**From:** Phillips, Duane [PhillipsDuane@stanleygroup.com]  
**Sent:** Wednesday, July 02, 2008 10:19 AM  
**To:** ndpsc@nd.gov  
**Cc:** akoeckeritz@otpc.com; Jerome C. Kettleson; jolson@minnkota.com; rsjohnson@otpc.com  
**Subject:** Updated Minnkota Power Cooperative Change Summary Pillsbury-Fargo  
**Attachments:** psc poles(1).pdf

As the design engineering firm and on behalf of Minnkota Power Cooperative, I am respectfully submitting the attached Change Summary drawings associated with the Pillsbury-Fargo 230kV Wind Generation Tie transmission line. This represents proposed changes to the transmission line alignment from what was submitted at the PSC Hearing dated May 22nd, 2008.

Summary & Explanation of Changes

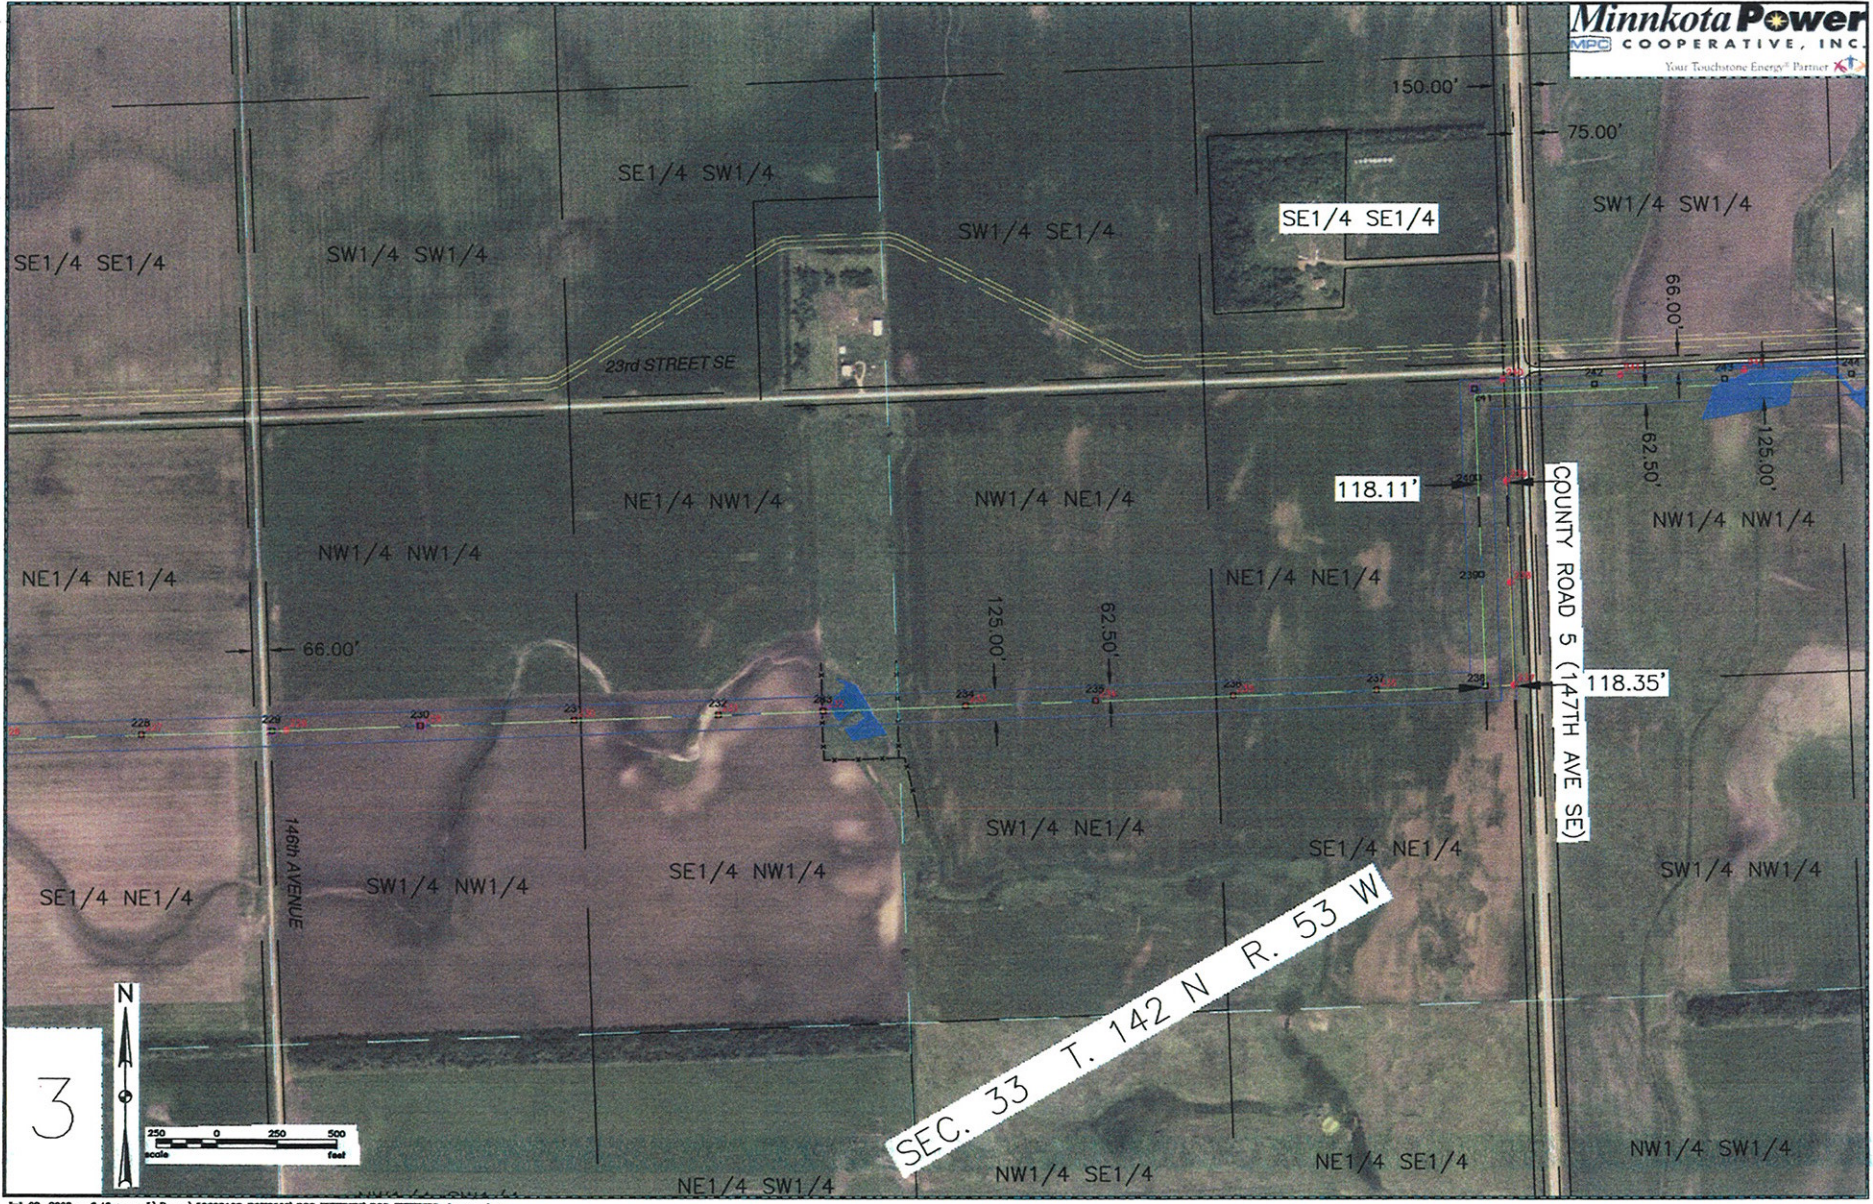
Sheet 1 & 2          Structures 31 - 40          This entire line of structures was moved 20' east in order to better accommodate land owner concerns regarding farming activities

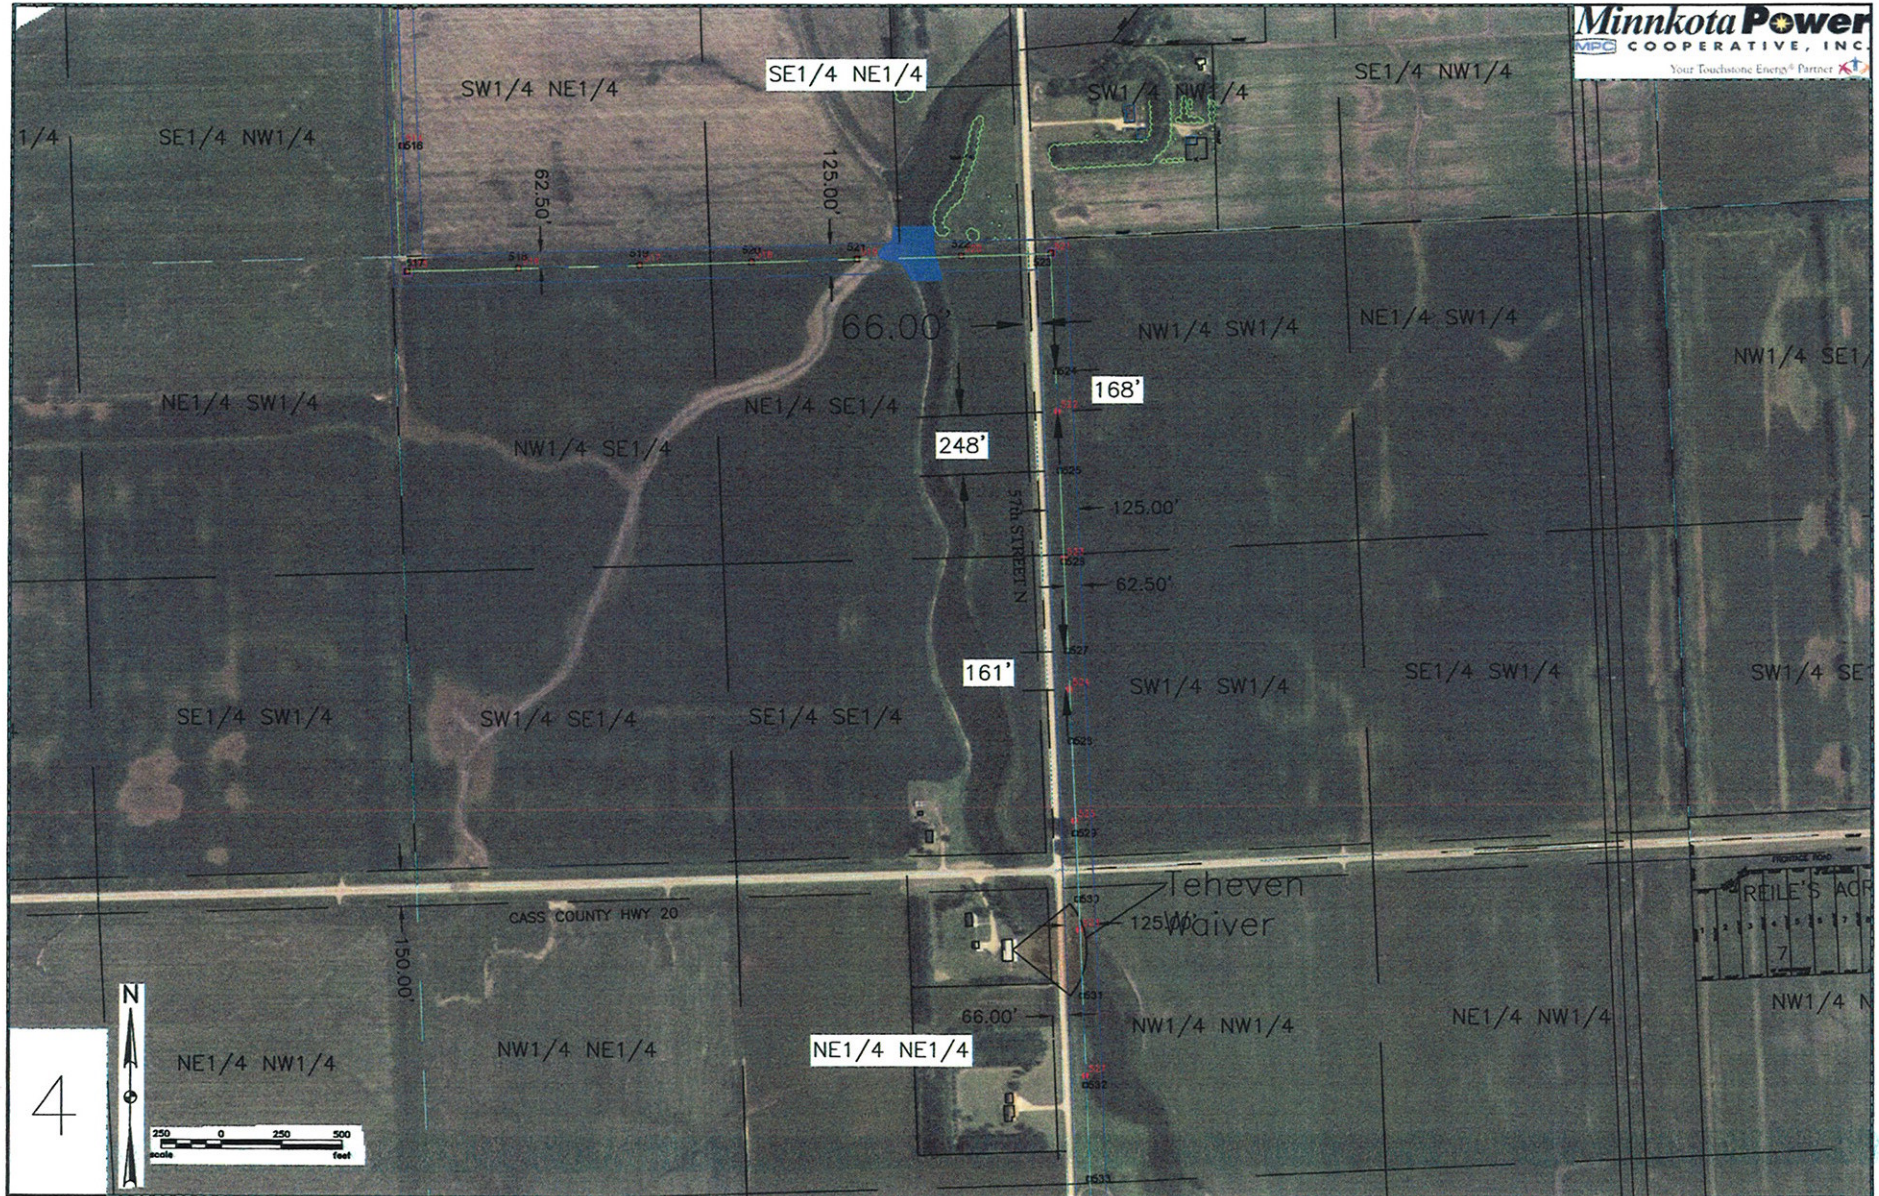
Sheet 3              Structures 238 - 241          This entire line section was moved 118' west in order to better accommodate land owner concerns regarding farming activities
